ALERT SERVICE BULLETIN

NO. 230-00-18

MODEL AFFECTED: Model 230

SUBJECT: HYDRAULIC ACTUATOR SUPPORT P/N 222-040-125-001, INSPECTION OF

Hydraulic Actuator Support Assembly
P/N 222-040-125-001
Figure 1

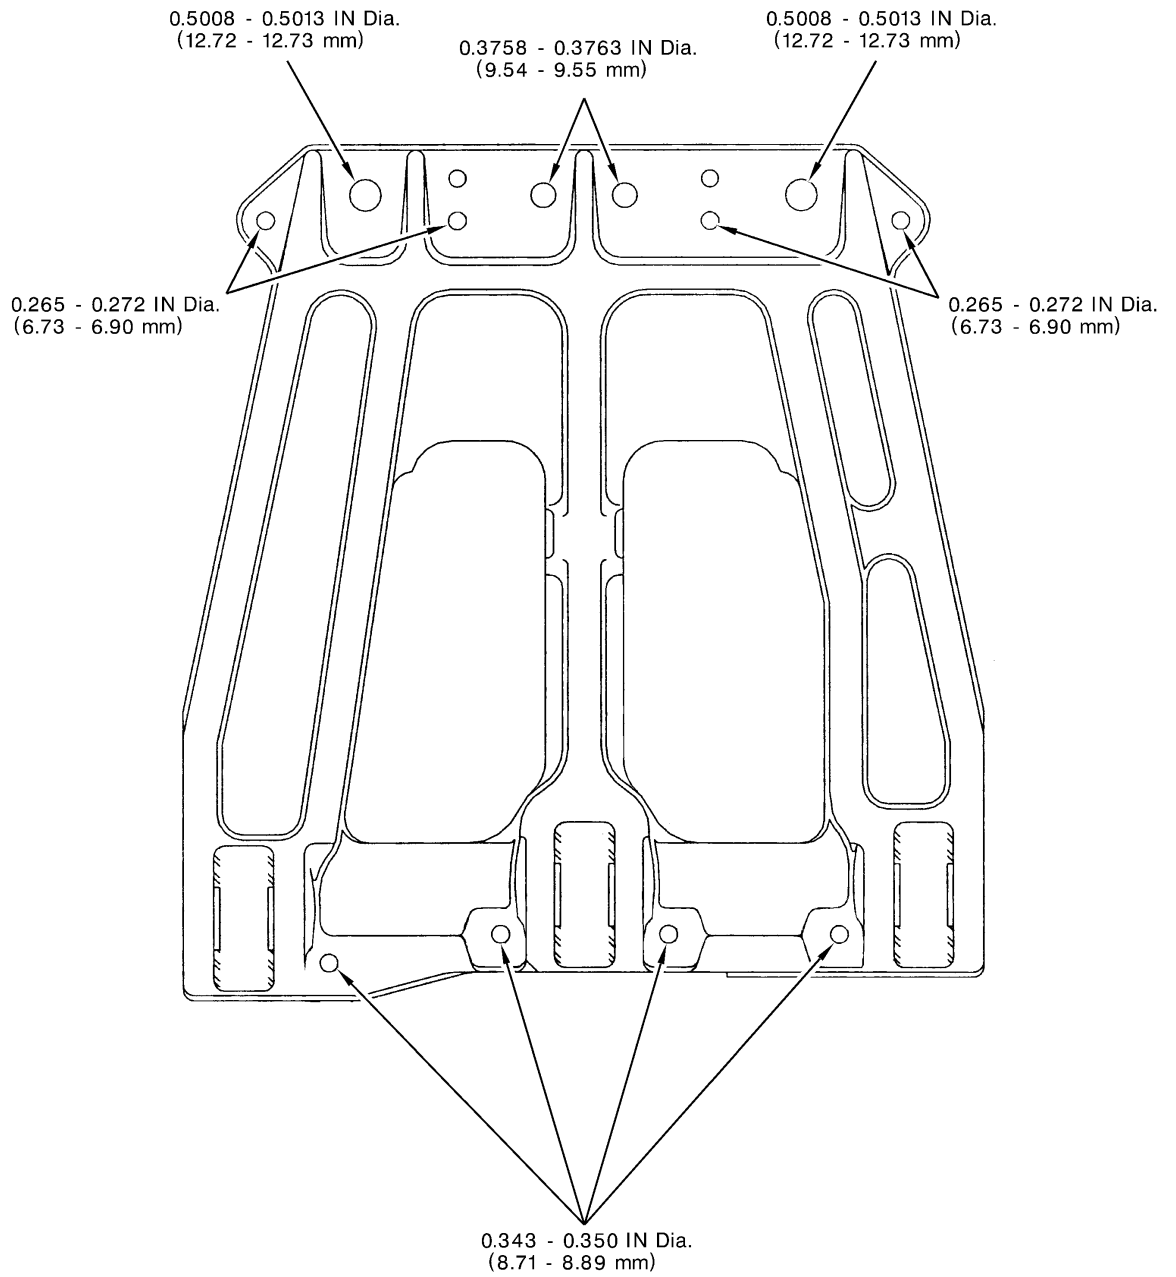
4. If two or more of the nuts within the upper row of the support attaching nuts move below 40 in.lb torque or two or more of the nuts within the lower row of the support attaching nuts move below 90 in.lb torque, remove the hydraulic actuators support from the transmission for further inspection and repair. Refer to BHT-230-MM-6, Chapter 63 and BHT-230-CR&O-2, Chapter 63 for removal instructions. Discard nuts and washers.
5. If required, inspect the support P/N 222-040-125-001 in accordance with instructions in BHT-230-CR&O-2, Chapter 63. The holes at the lower and upper end of the support were manufactured to the dimensions shown in Figure 1.

Transmission Top Case Assembly
P/N 222-040-061-105
Figure 2

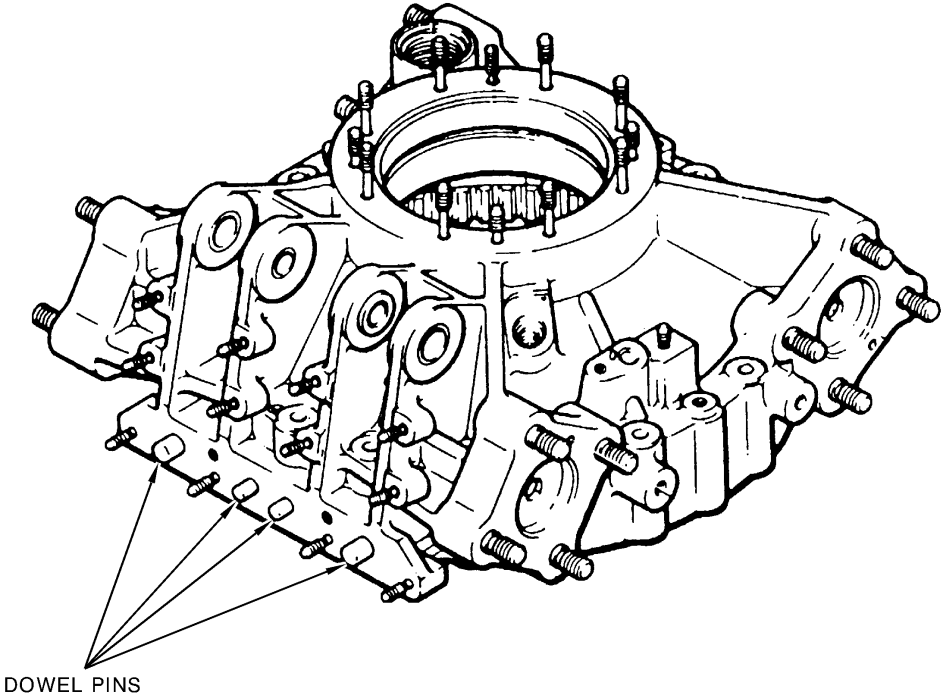
- c) Inspect the dowel pins in transmission case for damage, fretting, corrosion and looseness. The large outboard pins should measure 0.500 inch minimum and protrude 0.55 inch from the surface of the case. The small inboard pins should measure 0.375 inch minimum and protrude 0.45 inch from the surface of the case. Refer to Figure 2
